The IPC envelope ideally balances providing public amenity in the popular Darling Harbour Precinct with permitting redevelopment that is profitable for Mirvac.

ADJUSTMENTS REQUESTED BY IPC

1. A maximum podium height of RL 11.8 applying to the entire portion of the podium to the north of the proposed tower

a. The IPC Envelope:

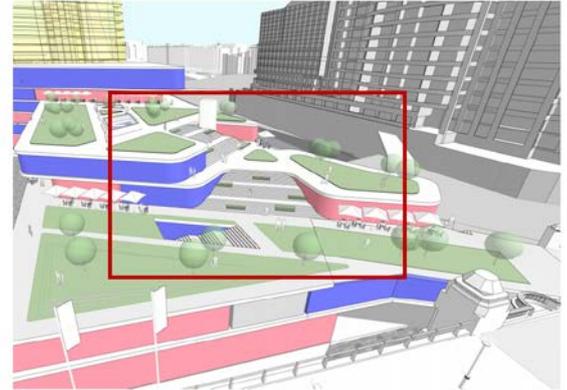
- i. One contiguous tier to the tower at RL 11.8 addresses the fundamental issue that Darling Harbour attracts many families who have small children and bring prams or bring elderly family members and **that a public amenity must meet their needs to be fairly considered provision of public benefit.** Additionally, one contiguous tier is essential to provide fair disabled access to the public amenity, so that they are not excluded or deterred from using the amenity.

- ii. **Having the one level tier at RL11.8 extend from Pyrmont Bridge to the Tower at one level is consistent with the Cockle Bay Wharf redevelopment,** as it also has one level tier of 12m from the Pyrmont Bridge to the Tower.

- iii. The foreshore of the proposed Harbourside Redevelopment is an essential part of many members of the public's daily life as they enjoy walks along the water. **The Northern Podium height at RL11.8 significantly improves the solar and sky access at the foreshore,** particularly as there is no more overhang to shadow most of the walkway. The Northern Podium will only be widened from 11m to 14m, and as the narrowest part of the public foreshore of entire Harbourside Redevelopment site, would significantly benefit from the increase in solar and sky access.

- iv. **Achieves genuine view sharing with One Darling Harbour (ODH) residents.** Most residents either maintain or improve their existing water views of Cockle Bay, with the primary impact to views being partial framing by the 170m tall tower. At the RL11.8 height, additional landscaping height will still achieve view sharing with ODH residents.

- v. **Importantly respects the significant heritage Pyrmont Bridge,** as the Northern Podium will not be dominating as it is no longer higher than the Pyrmont Bridge.

- vi. **Provides an opportunity to allow event and gathering capacity** to replace what is lost by narrowing the widest part of the foreshore where the Ferris Wheel currently sits.

Figure 1- Slide 83 of PPPS <https://www.planning.nsw.gov.au/-/media/Files/DPE/Strategy-documents/Plans-for-your-area/Planning-for-local-communities/Pyrmont-Peninsula/Pyrmont-Peninsula-Place-Strategy-2020-12-11.pdf?la=en>

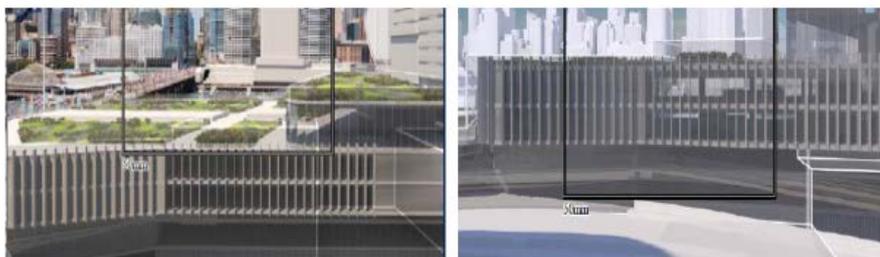
- i. There are a number of strategy objectives in the PPPS, Mirvac appears to pick and choose strategy objectives, focusing on building a tower of 170m in height without delivering publicly accessible open space on rooftop **areas** (no access to Southern Podium) or safe, activated and inviting streetscape on service areas (no design excellence applied to back of house areas).

PODIUM HEIGHT - RELATIONSHIP WITH SURROUNDING BUILDINGS

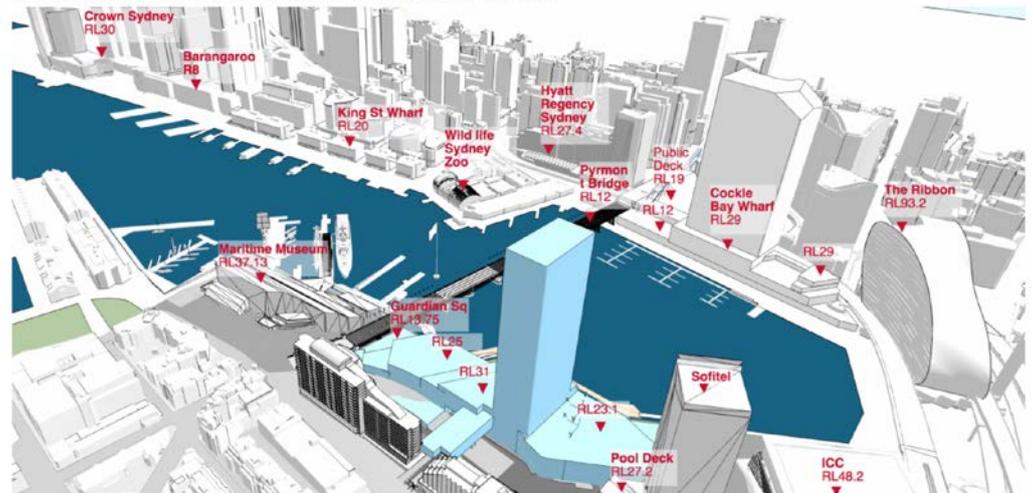
- f. *Un-balanced massing (all density at the central and southern end)*
 - i. The Cockle Bay Wharf Redevelopment also does not have balanced massing, as the southern end is at RL29 whereas the northern end is at RL12.
